# Access Compliance Report

## Public Rights-of-Way

Intersection ID: 10022511	Main Street: CARANNA_CT	Cross Street: N/A	Location: NE
ADA ID: 7EE2903DED08	Ramp Type: Perp	Initial Pass/Fail: Fail	Overall Compliance: No
Severity Score: 21.25			
Codes/Mitigation Info/Possible Solution		Field Measurements/Component Compliance

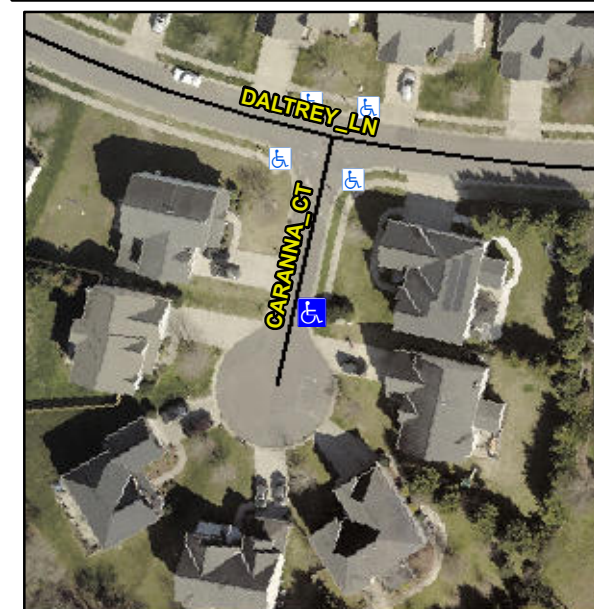
**Not Found, R304.5.1, R304.5.3**

Compliance	Description	Data	Compliance	Description	Data
N/A	Ramp Length (in)	49.0	Yes	Ramp Slope (%)	5.7
No	Ramp Width (in)	41.0	No	Ramp XSlope (%)	6.5
N/A	Flare Type LT	N/A	N/A	Flare Type RT	N/A
N/A	Flare Slope LT (%)	N/A	N/A	Flare Slope RT (%)	N/A
N/A	Flare Traversable LT?	N/A	N/A	Flare Traversable RT?	N/A
N/A	Landing Length (in)	N/A	N/A	DWS Provided?	N/A
N/A	Landing Width (in)	N/A	N/A	DWS Contrast?	N/A
N/A	Landing Slope (%)	N/A	N/A	DWS Length (in)	N/A
N/A	Landing X Slope (%)	N/A	N/A	DWS Full Width?	N/A
N/A	Landing Curb? (Y/N)	N/A	N/A	DWS Offset (in)	N/A
N/A	Shared Landing?	N/A			
N/A	Gutter Ponding?	N/A	N/A	Gutter Slope (%)	N/A
N/A	Gutter Lip Ht (in)	0.5	N/A	Gutter X Slope (%)	N/A
N/A	Painted X Walk1?	No	N/A	Painted X Walk2?	N/A
	X Walk 1 Direction	To NW		X Walk 2 Direction	N/A
N/A	X Walk 1 Width (in)	N/A	N/A	X Walk 2 Width (in)	N/A
	X Walk 1 Slope (%)	1.4		X Walk 2 Slope (%)	N/A
	X Walk 1 X Slope (%)	0.7		X Walk 2 X Slope (%)	N/A

**Remove & Replace Entire Ramp.**
